COUNCIL ASSESSMENT REPORT

Panel Reference	PPSSEC-111
DA Number	DA-2020/468
LGA	Bayside Council
Proposed Development	Integrated development for the demolition of existing structures and construction of an eleven (11) storey commercial office development with rooftop terrace and above ground parking
Street Address	32-34 Ricketty Street Mascot
Applicant/Owner	Linkcity Pty Ltd/ Elegant Capital Pty Ltd
Date of DA lodgement	22 December 2020
Total number of Submissions Number of Unique Objections	Nil
Recommendation	Approval
Regional Development Criteria (Schedule 7 of the SEPP (State and Regional Development) 2011	Development with a CIV of \$81,015,000
List of all relevant s4.15(1)(a) matters	• Environmental Planning & Assessment Act 1979, Part 4 – Development Assessment & Schedule 7 of the SEPP- State and Regional Development 2011 which regional panels may be authorised to exercise consent authority functions of councils • Environmental Planning & Assessment Regulation 2000, Part 6 – Procedures relating to Development Applications • Integrated development- Water Management Act 2000 • State Environmental Planning Policy (Infrastructure) 2007 • State Environmental Planning Policy No. 55 –

Figure 2: Impact of site constraints on potential basement parking footprint & resultant levels.

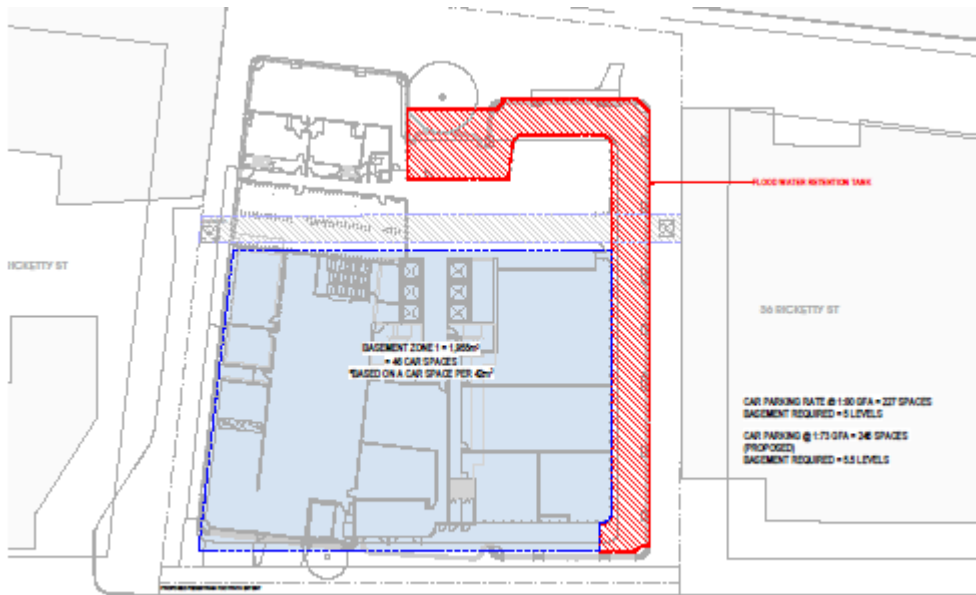
Mention was also made of façade planters, whose plan allocations appear not to be fully considered. It was suggested too that perhaps the green wall treatments of the front and rear facades could be opened up more (for parking level cross ventilation) and be extended similarly along side elevations.

- The constraints presented on site for an underground car park are;
- Council Storm water Easement which dissects the site
- Provision for deep soil landscaping
- Requirement for an OSD Tank
- Poor ground conditions & High water table
- Future adaptability of aboveground car parking levels

With all these constraints considered, the design would require a basement of 6 levels as shown in Figure 2. The resulting basement would also be significantly less efficient and cost prohibitive.

Figure 3: Revised Building Top / Capping Detail (refer to Images further down in report for additional imagery)

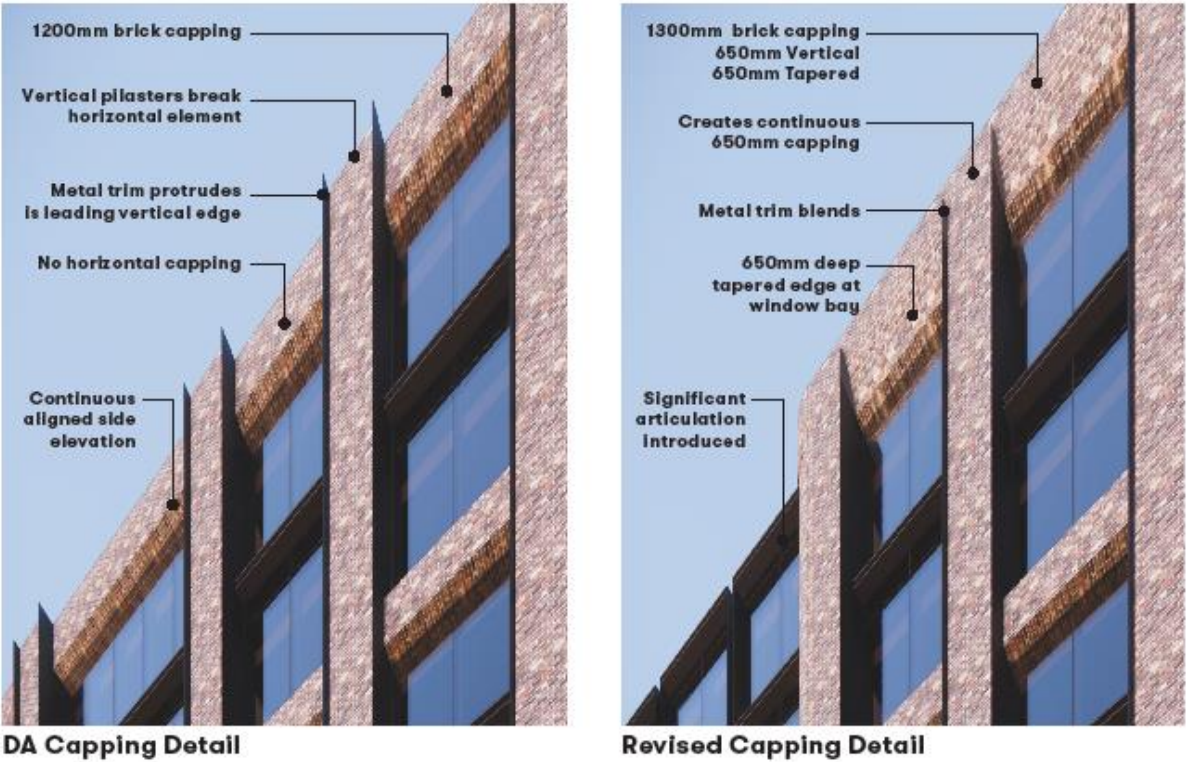
The current and future context was discussed at length at the last design review panel meeting. The Panel noted the applicants' response to the physical context, such as site size and location, evolving nature of the context, traffic impacts, local influences and the retention of existing trees. In principle, the Panel supported the provision of high quality office space, associated retail and welcomed the retention of the large trees along Ricketty Street and through site link – which appears to align with desire lines to Mascot Station. However, the Panel was concerned about the proposal's bulk and scale, which although generally compliant with the LEP's 44m height requirements, appeared not to align with its relatively low 3:1 density. The Panel's concerns generally related to:

In response to the DRP comments, the design has refined its approach to the top of the built form and building capping by increasing the proportion of the top parapet with both flat and tapered sections to elegantly terminate the top of the built form as shown in Figure 3. The amended approach addresses the panels concerns in a considered manner, whilst retaining the essence of vertical expression the original design intent of vertical expression.

Figure 4: Relationship eastern colonnade to boundary and future built form envelope.

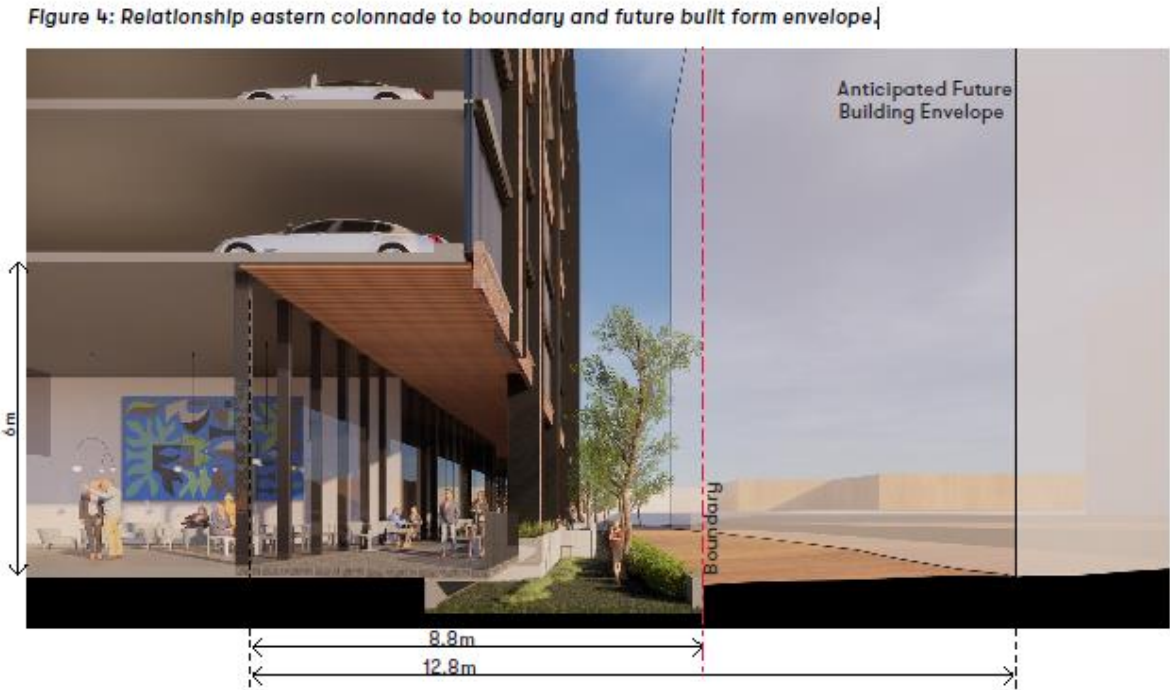
- the adequacy of 4m side setbacks at such a height and length in the provision of light, air and outlook to internal spaces
- the likely open space quality, landscape character and pedestrian amenity of the through site link and/
- the likely spatial quality and urban character of a future context populated with buildings of a similar mass and scale

As shown in Figure 4 below and in the context & neighborhood section above, the design doubles the minimum building setback at tower levels, and over 4 times the minimum setback at the double height ground plane along the western colonnade, achieving a positive outcome for the development.

Level 10 - Proposed layout

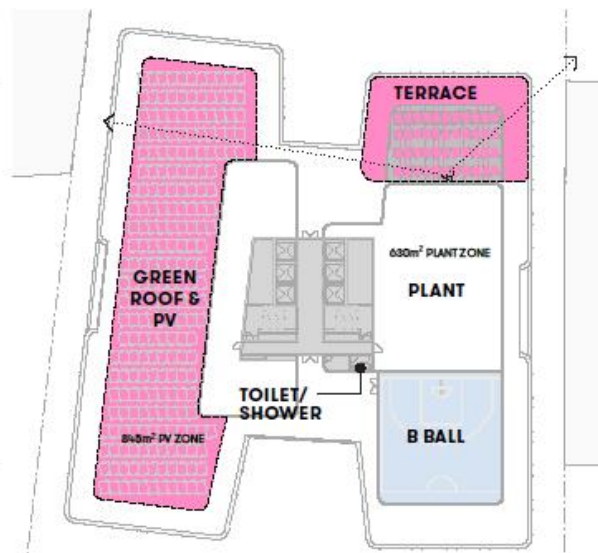
The Panel has made comments regarding consolidating the two separate recreation areas on the rooftop terrace. While in theory, combining the two areas would provide a secure and activated area, the applicant's intention that the northern section be used for passive recreation while the southern side is used for active recreation is supported by Council as it allows noise generating sources to be located away from the seating area. Additionally, incorporating BBQ and kitchen facilities on the rooftop will contribute to additional bulk and greater FSR. It is not considered that a shower facilities on this level is required particularly as this has been provided in the development at ground level within the end of trip facility area.

The design team has undertaken a spatial testing exercise in response to the DRP comments related to the basketball court location (indicated on the below diagrams).

- The southern location provides shade, visual and noise protection of the court and its users.
- Shifting the court to the north-western wing significantly impacts the solar panel and green roof design, due to overshadowing of the PV panels and inefficiency in design/layout resulting in a fragmented allocation of PV.
- Separating the two functions ensures that activities can take place concurrently without (i.e. a tenant function being held at the northern terrace is not disrupted by loud use of the court at the same time).
- Retaining the green roof & solar panels provides an eye level vista for the terrace users, connecting people to nature and sustainable building technology, whilst providing uninterrupted views to the north.
